# BID #709 – Ventura College STEM Program Building Improvements

## **ADDENDUM 001, dated 05/15/2025**

**DRAWING** changes and clarifications noted as Addendum 01 and dated 05/15/2025:

CONCRETE BENCH

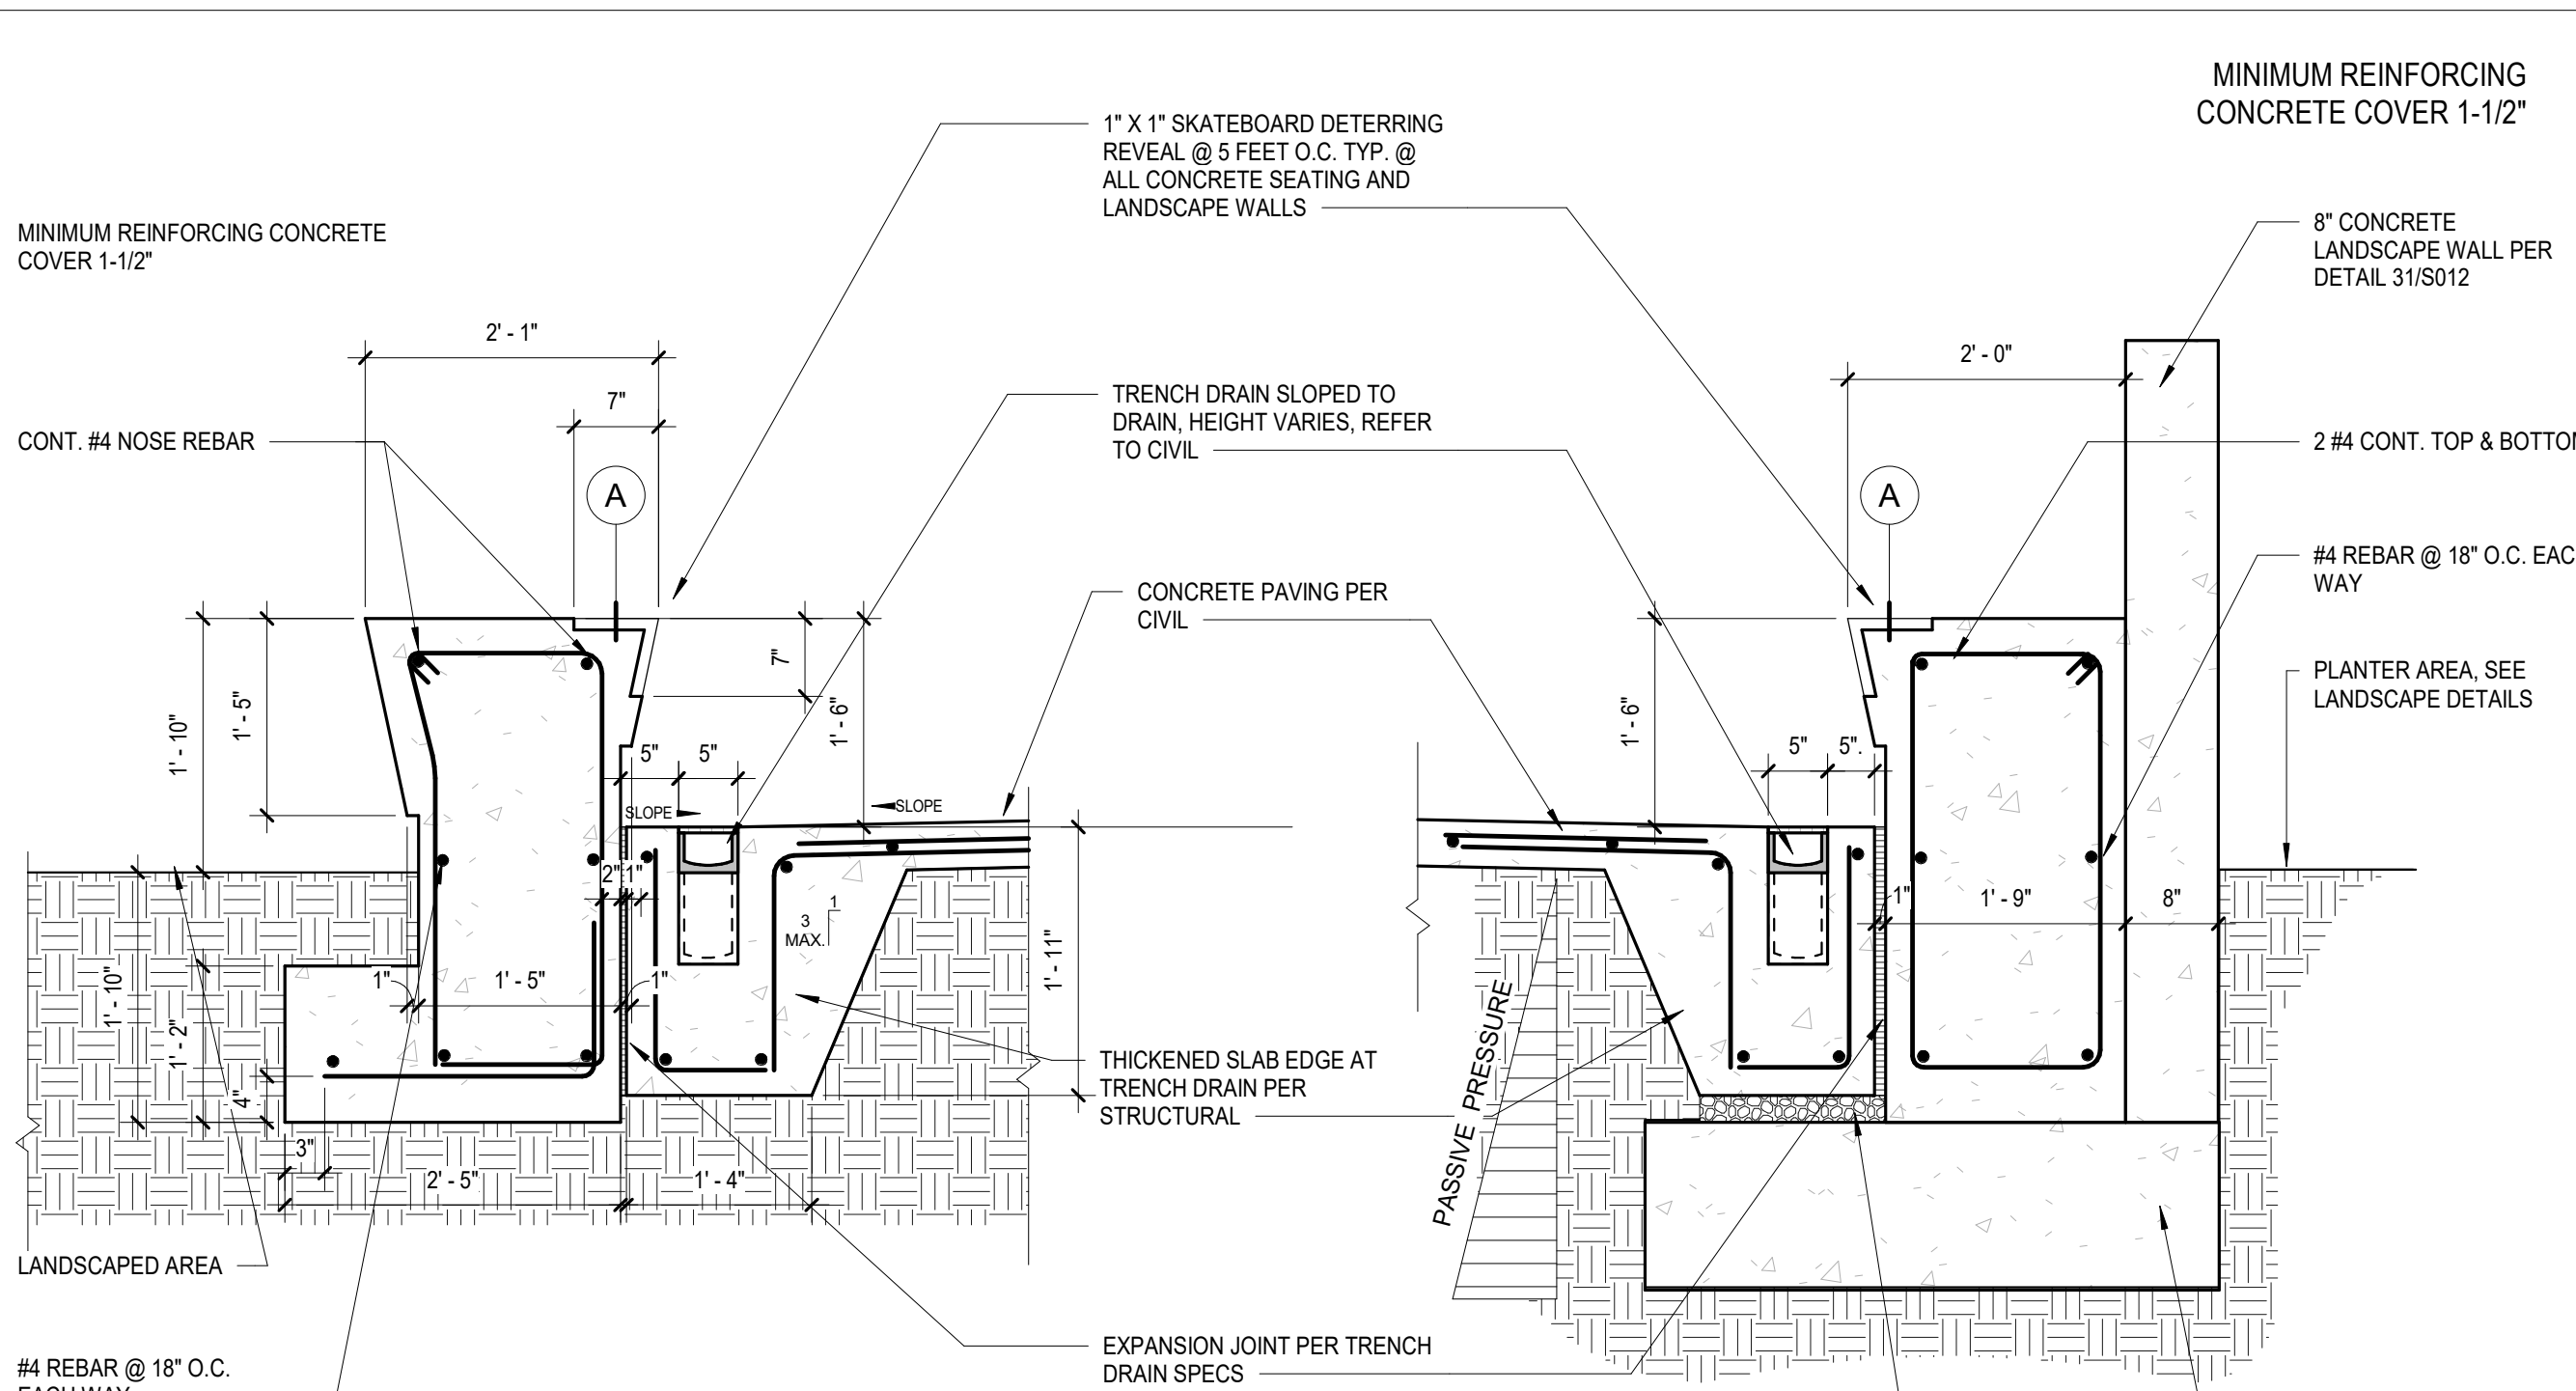
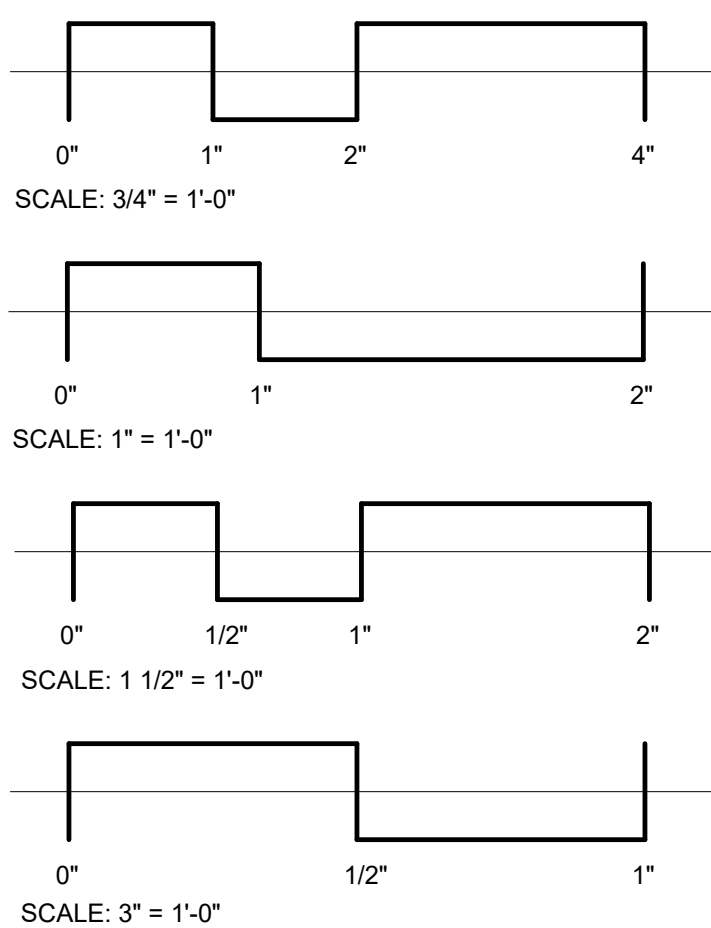
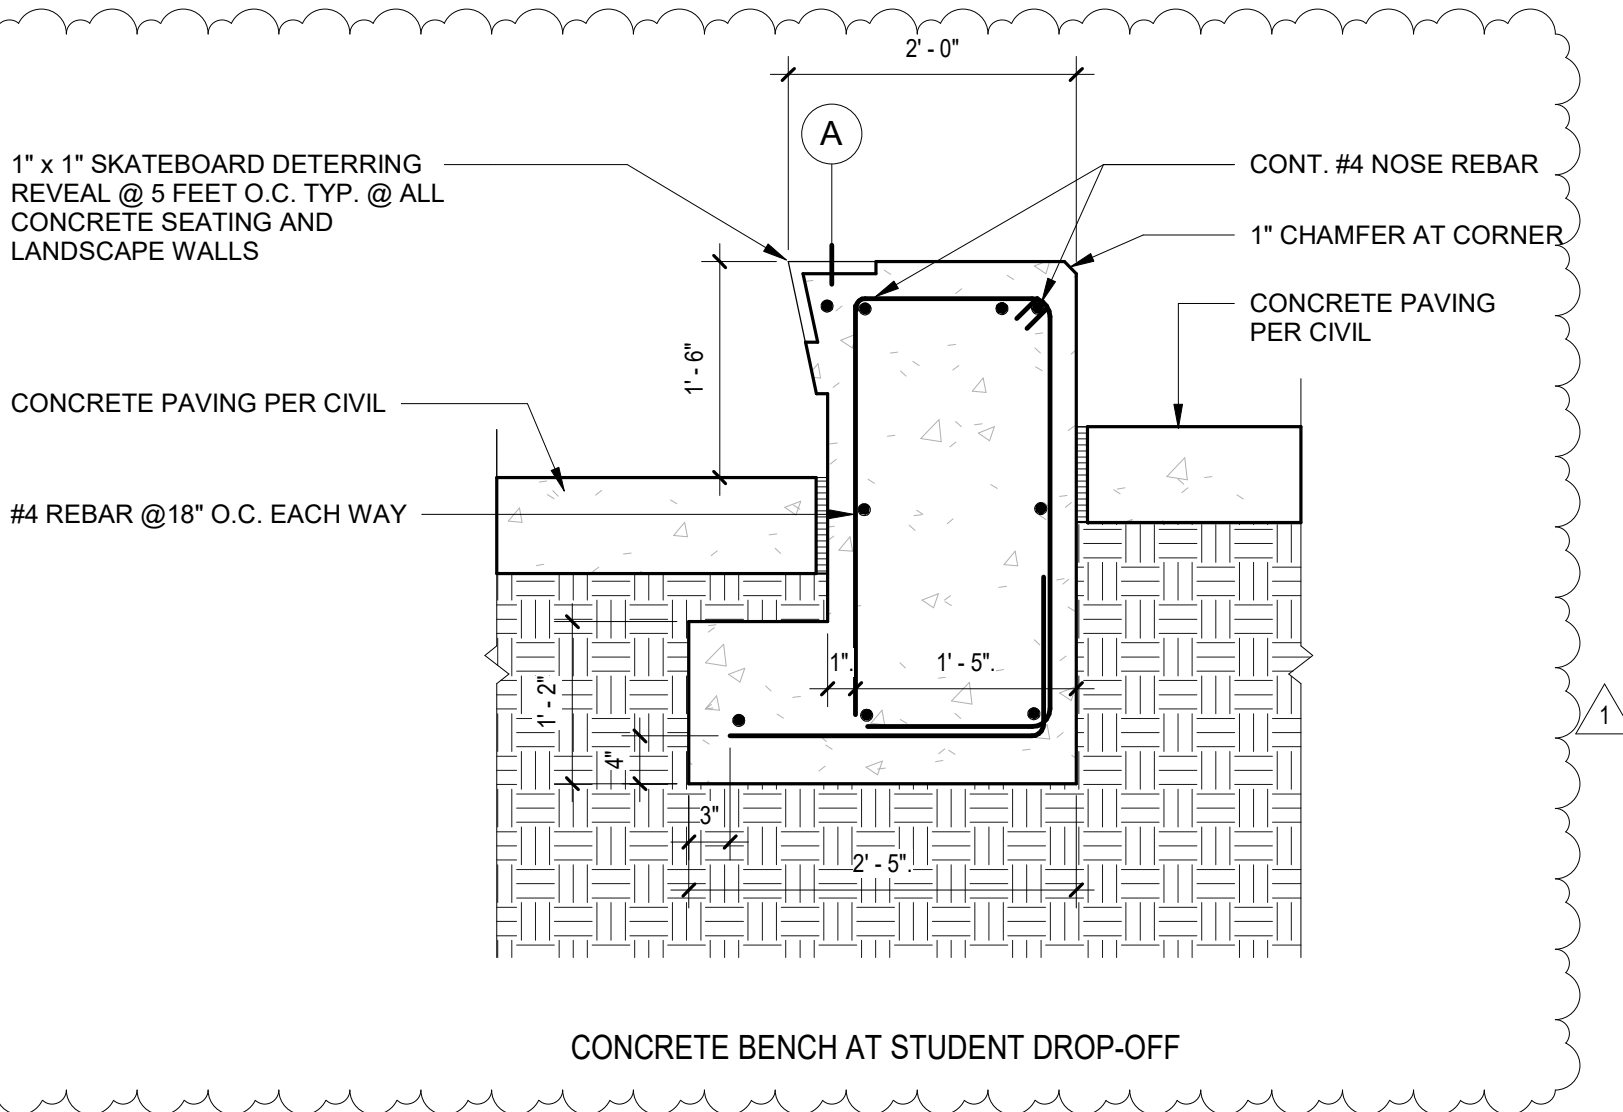
A501 – DETAIL 7/A501, CONCRETE BENCH AT STUDENT DROP-OFF ADDED.

SOUTH ELEVATION SITE

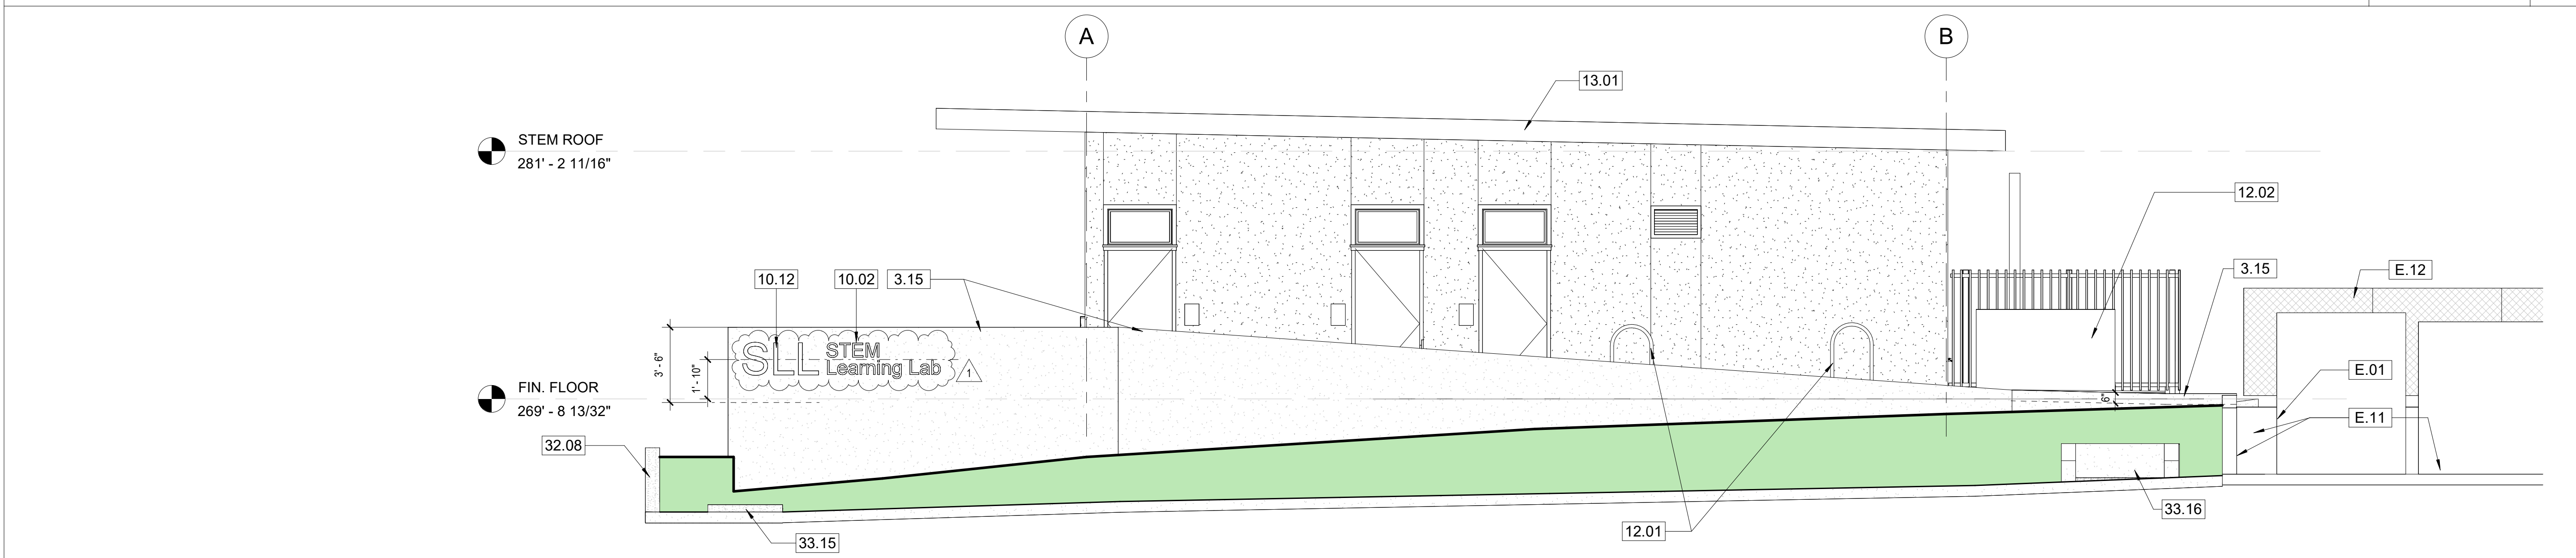
A202 – SITE EXTERIOR ELEVATIONS; 3/A202 SOUTH ELEVATION SITE, KN 10.02 BUILDING SIGN REVISED
